Ohio Museum Complex HVAC
Lin Hall, The Ridges – Ohio University
Athens, Ohio

ADDENDUM 02

Addendum to the drawings and specifications for: **Ohio Museum Complex HVAC**

H3.2

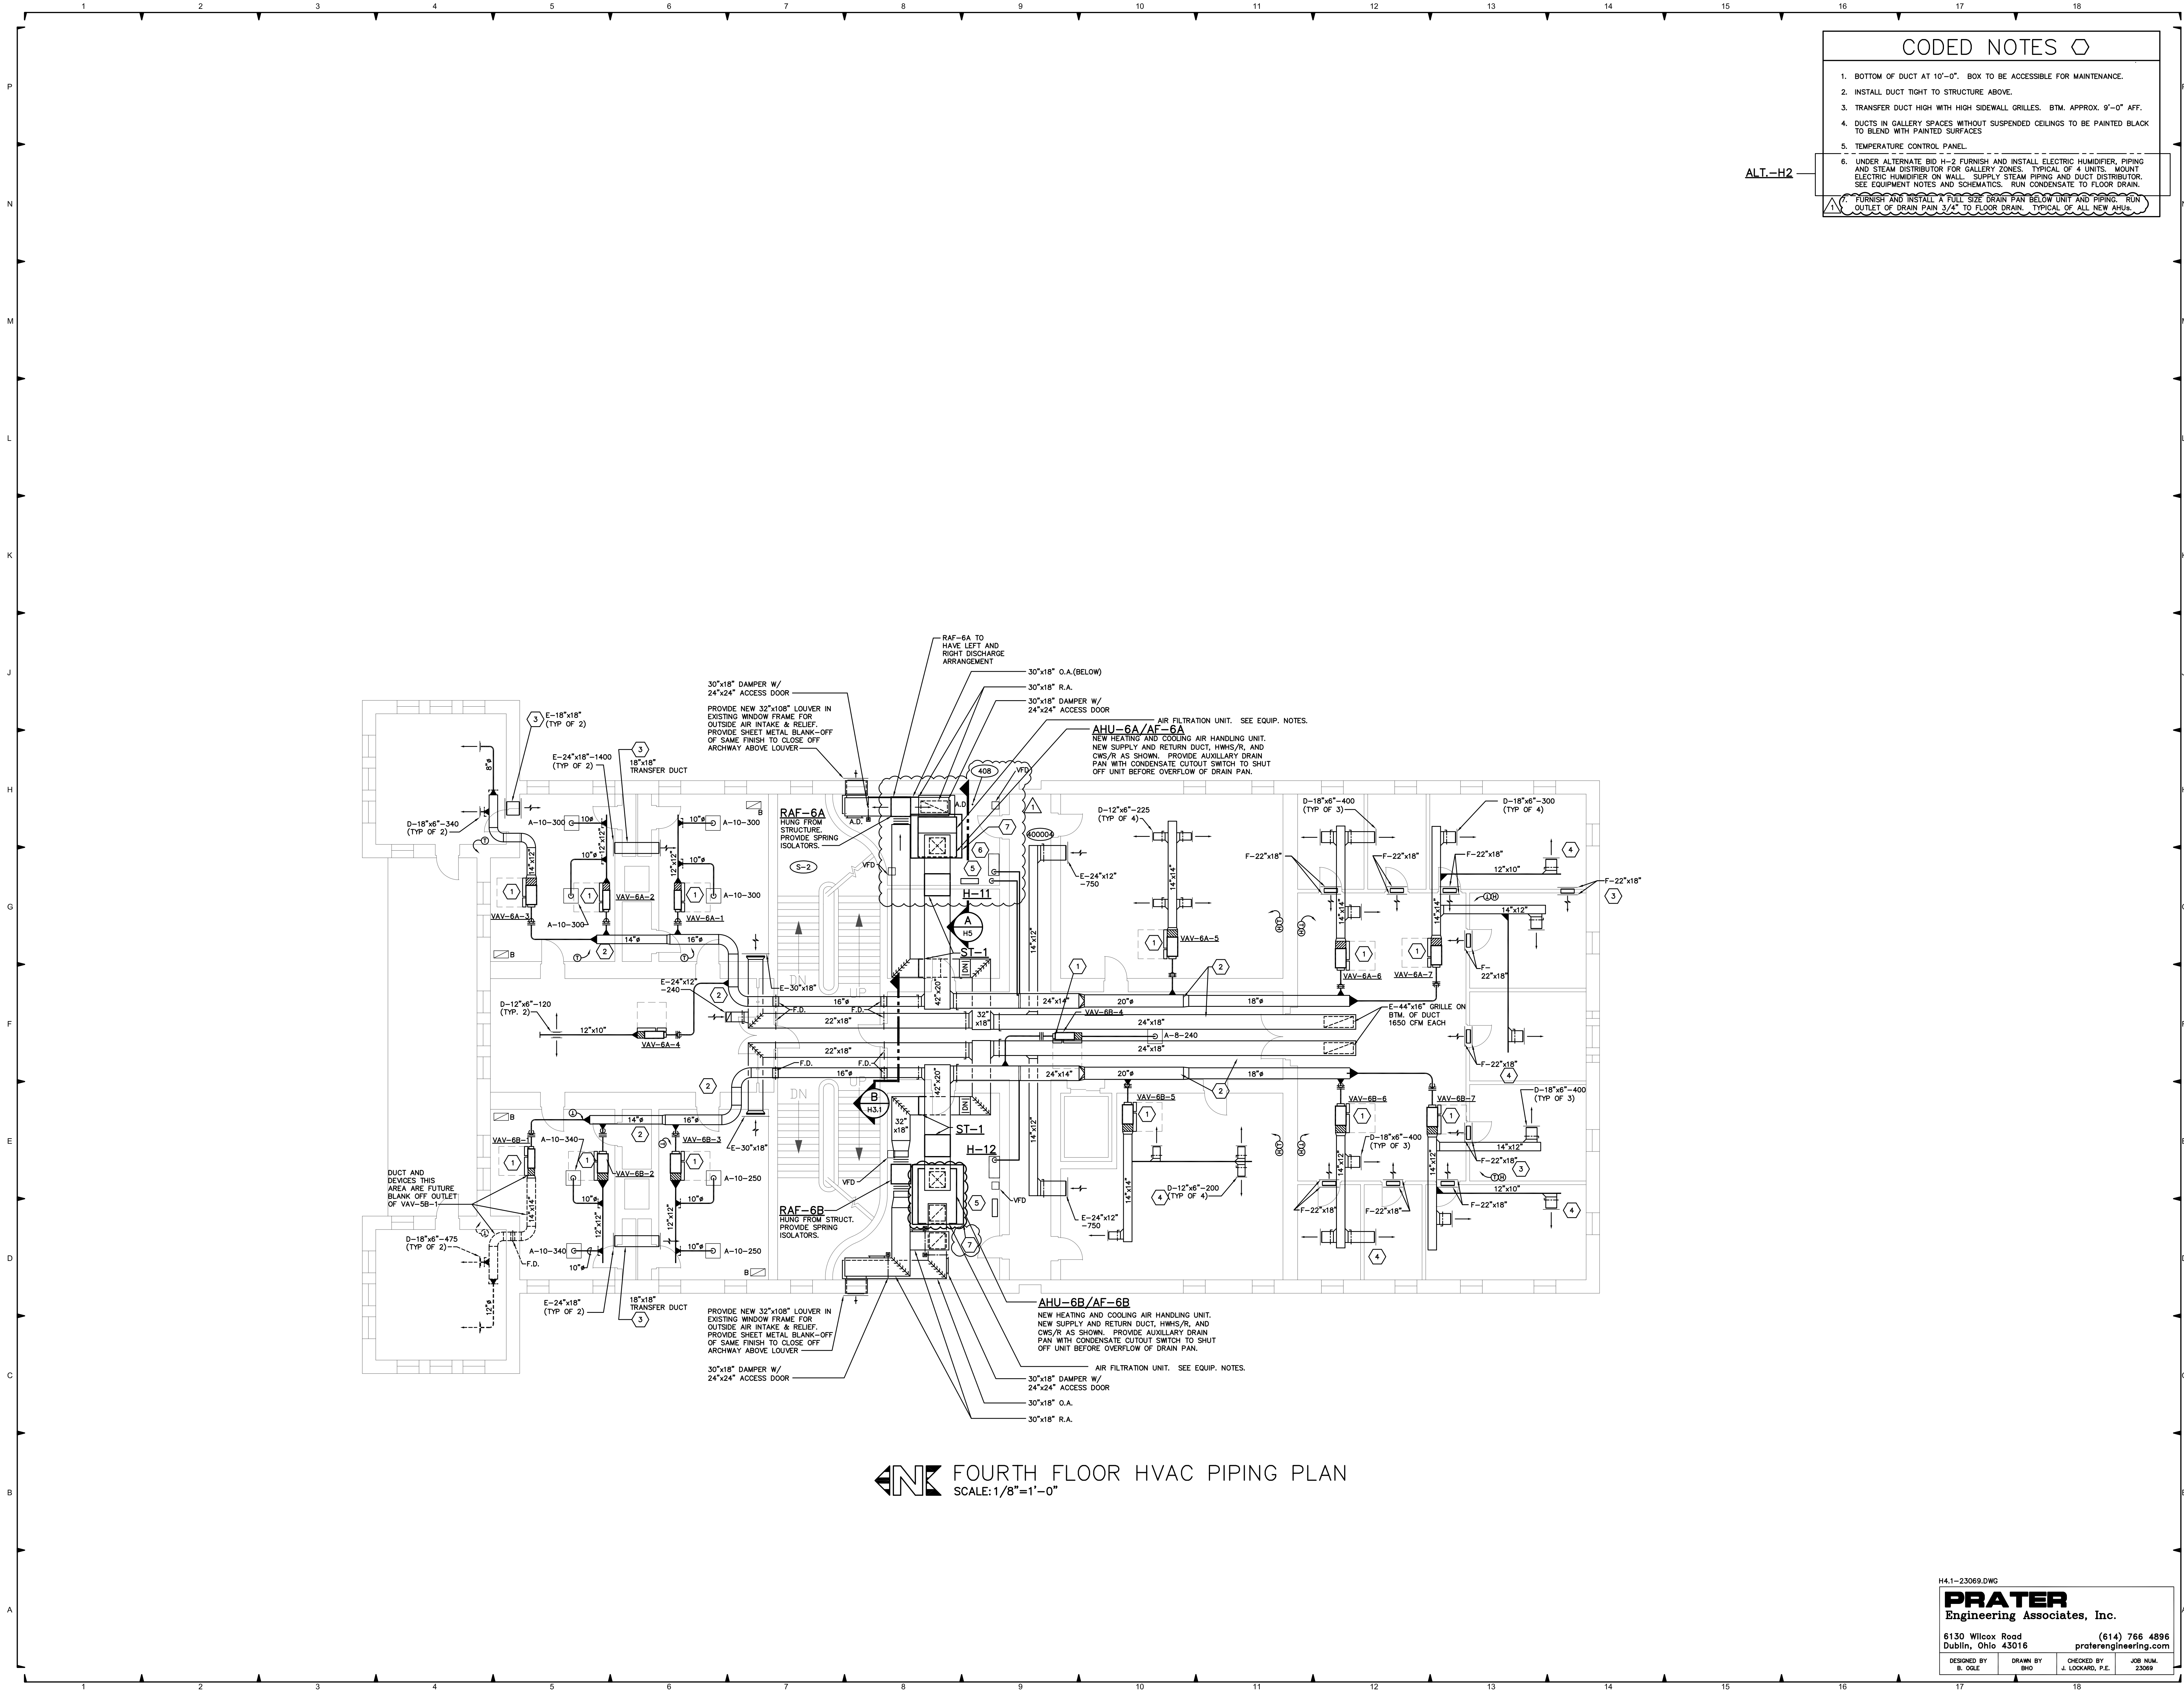
- 8. Sheet H3.2**
Relocated piping connections to AHU-5A.
- 9. Sheet H4.1**
Relocated AHU-6A and RAF-6A to reduce size of mechanical room.
Relocated VFDs, Temperature Control Panel and Humidifier unit H-9 in this room.
Added note to install full size drain pan under AHU units and coil piping connections.

PUMP DETAIL
NO SCALE

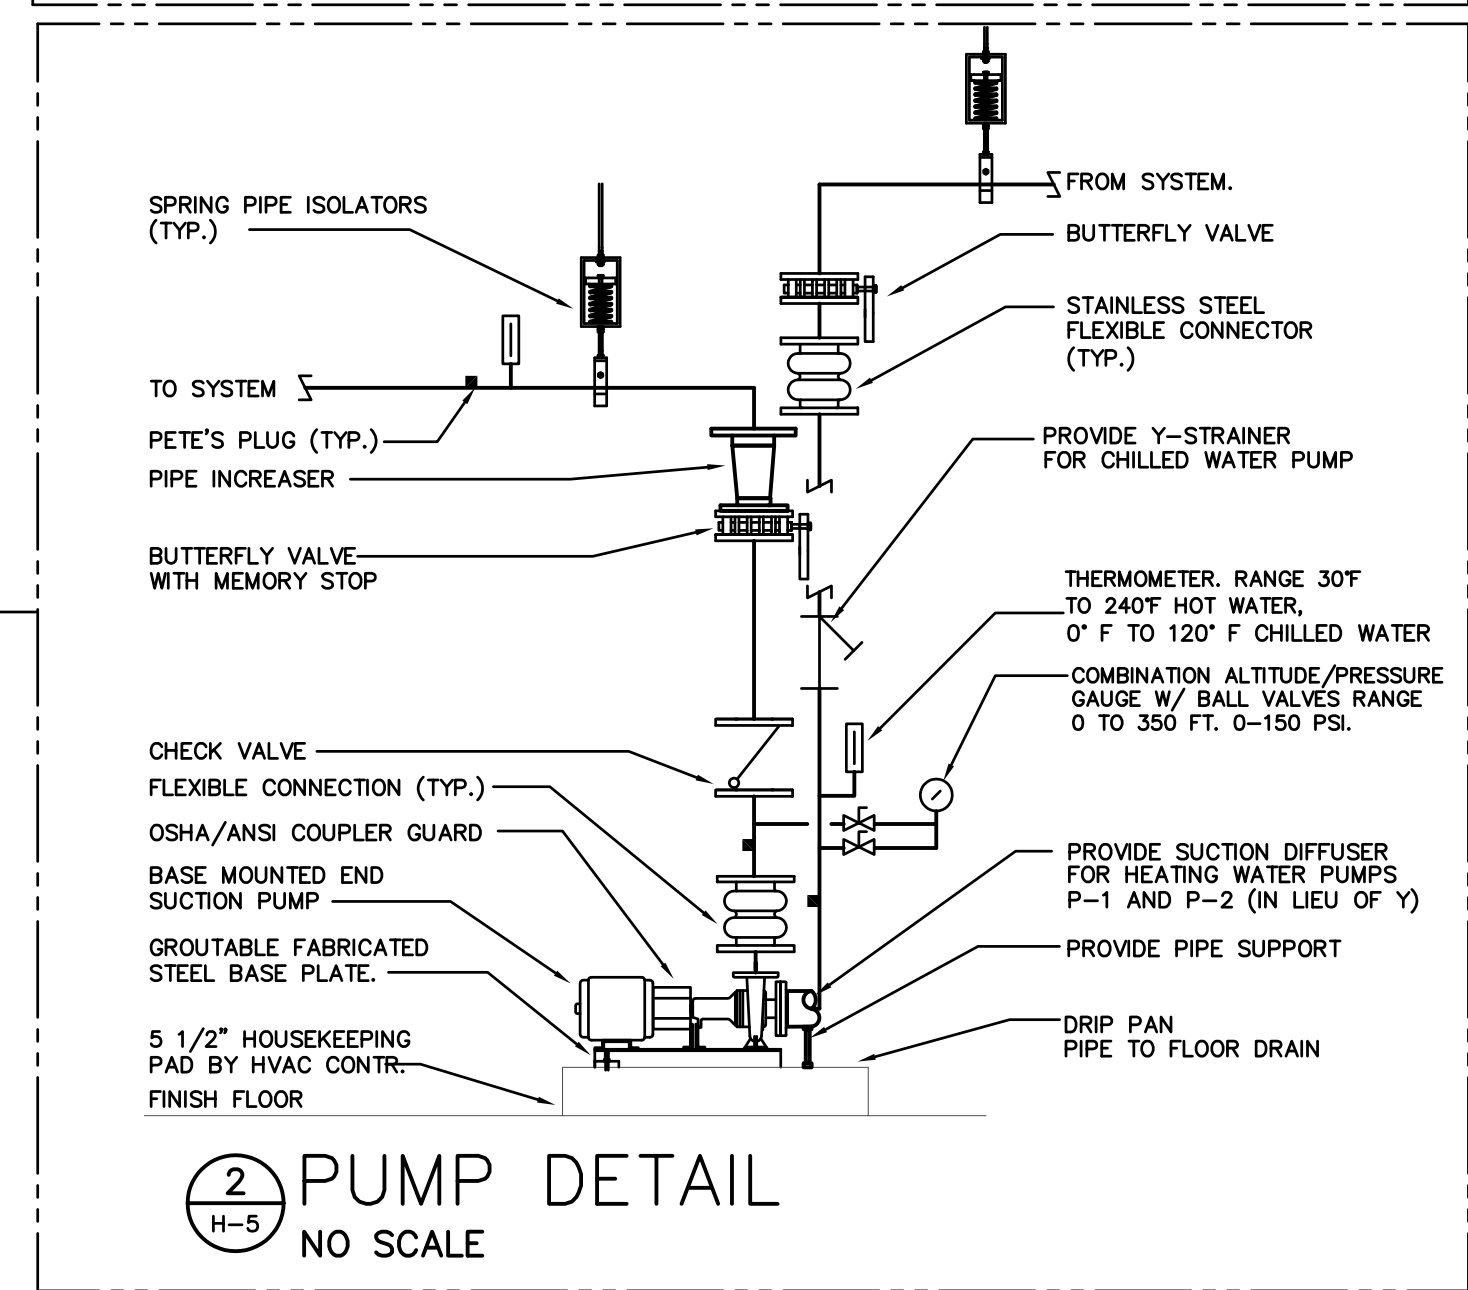
- 10. Sheet H4.2**
Relocated piping connections to AHU-A.
- 11. Sheet H5**
Removed fin tube radiation piping detail.
Added detail 3/H-5 to clarify Heating Water System Pump replacement is base bid work.
